MIL-C-45924(WC)
AMENDMENT 3
11 June 1976
SUPERSEDING
AMENDMENT 2
18 December 1975

MILITARY SPECIFICATION

CONTROL PANEL, GUNNER

This amendment forms a part of Military Specification MIL-C-45924(WC), dated 26 March 1974.

FIGURE I

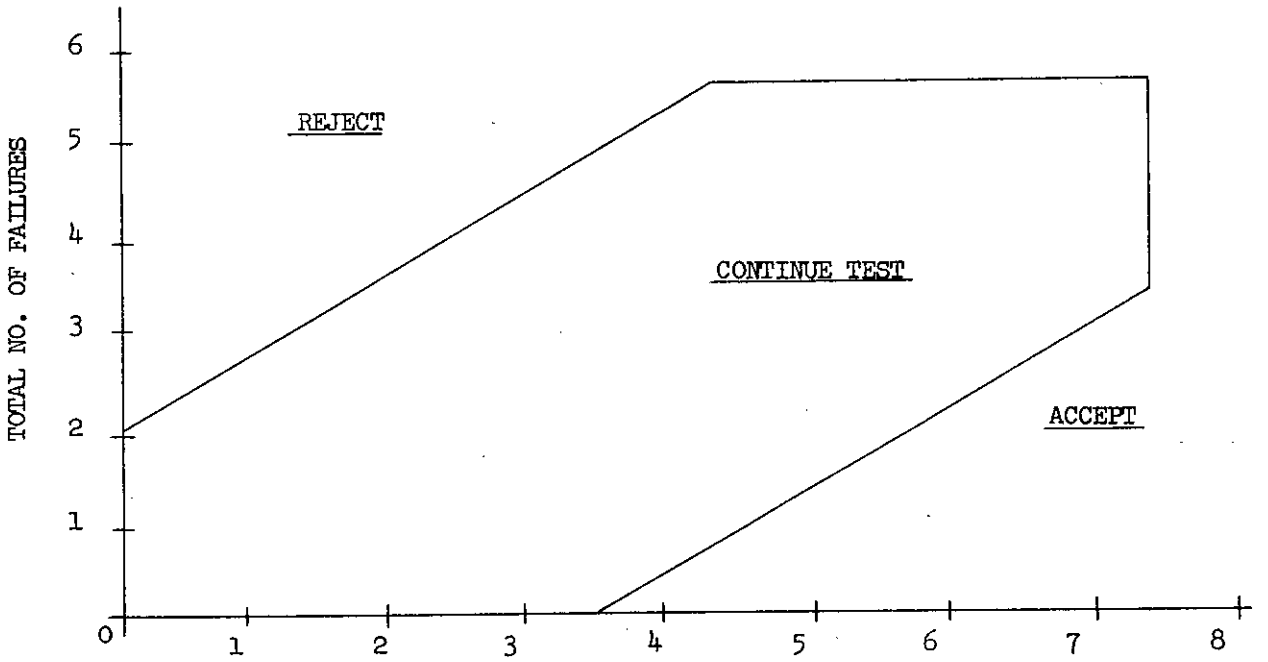
"4.6.2 Reliability test. When specified (see 6.2), the reliability test shall be performed by repeating the test cycle defined in 4.6.2.1. For each test cycle, the failure versus test cycle data shall be cumulatively plotted. Testing shall be terminated whenever a decision point, as defined in Figure 1, has been reached.

Add the following "Figure 1" as last page to the specification.

Decision Risks: 30%
Discrimination Ratio: 1.5:1
MIL-STD-781 Test Plan VII

NO. OF FAILURES	REJECT (EQUAL OR LESS)	ACCEPT (EQUAL OR MORE)
0	N/A	3418
1	N/A	4736
2	N/A	6054
3	1318	7373
4	2637	7373
5	3955	7373
6	7373	N/A
